**SUBJECT:** Concurrence Request to Use Site Specific Alternative Approaches to Demonstrate Modeled Attainment of the 2010 SO<sub>2</sub> NAAQS at the Alcoa West Aluminum Smelter in Massena, New York

## **EPA Region 2's Technical Review of New York State Department of Environmental Conservation's Request to Use Two Site-Specific Alternative Modeling Approaches in AERMOD**

Figure 2: Isopleths of default Aermod (left) and Modified Aermod with draft BPIPPRM (right)

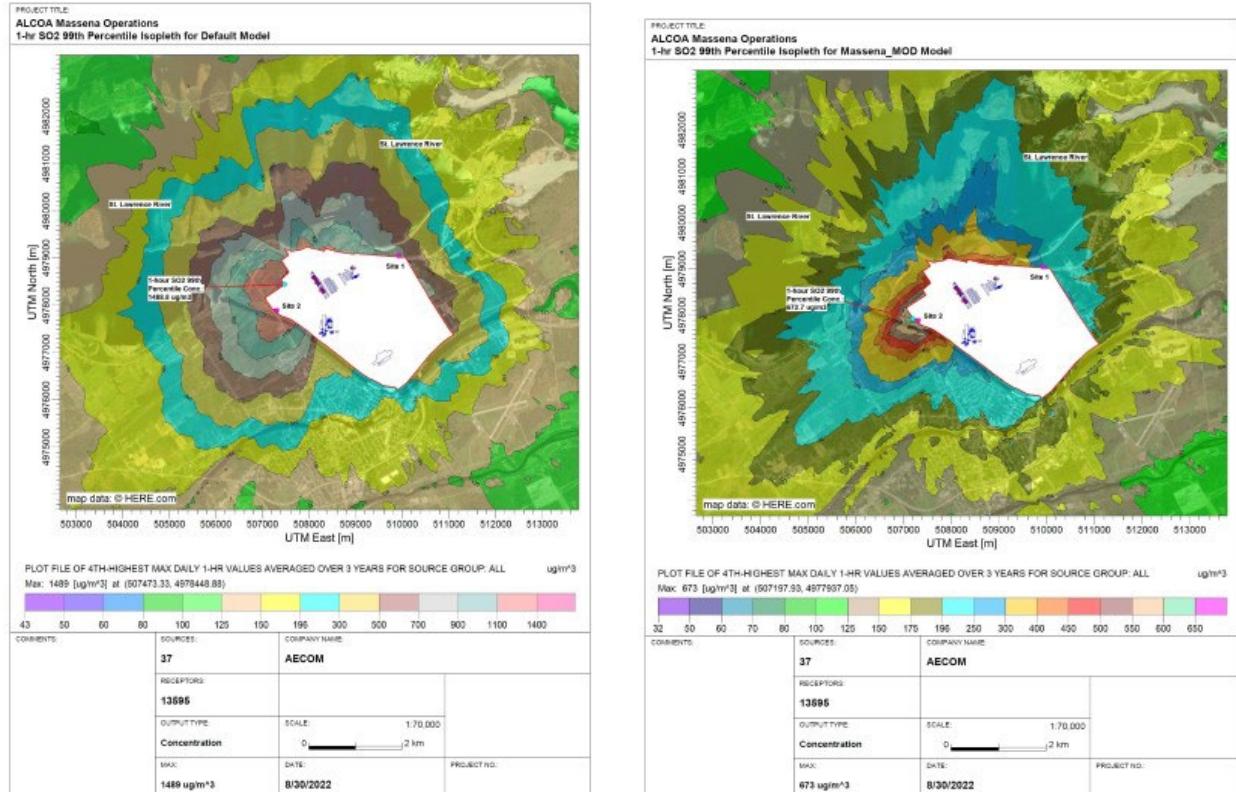
On August 30, 2022, at the request of EPA, Alcoa provide isopleths of the concentrations using the default AERMOD impacts and AERMOD with the modified preprocessors. EPA requested this information to better understand the effects of the draft BPIPPRM on the modeling domain. As seen in Figure 2, the plots of the isopleth show a shift in the maximum impact location downwind of the lee side of the long narrow single tiered building to the lateral edge of that downwind side. This is what has been shown in the wind tunnel studies to date indicating the draft BPIPPRM is working better in this case. Further as seen in Figure 3, the isopleths also align with the prevailing southwest/northeast wind direction that would be expected along the nearby St. Lawrence Seaway river valley.

Figure 4-5: Q-Q Plot For Site 1

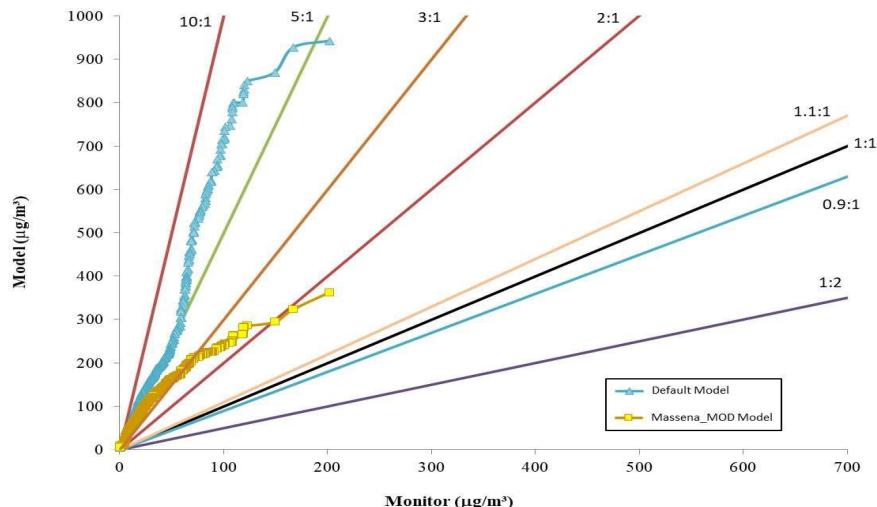
The two QQ Plots below from Figure 4-5 and 4-6 of the June 10, 2022 Modeling Protocol illustrate the improved model performance when taking the modifications into account. A concentration closer to the 1:1 line indicates a better correlation with measured data. In this case, the modified model's maximum concentrations are closer to the 1:1 line with smaller overpredictions indicating that there is still a conservative bias.
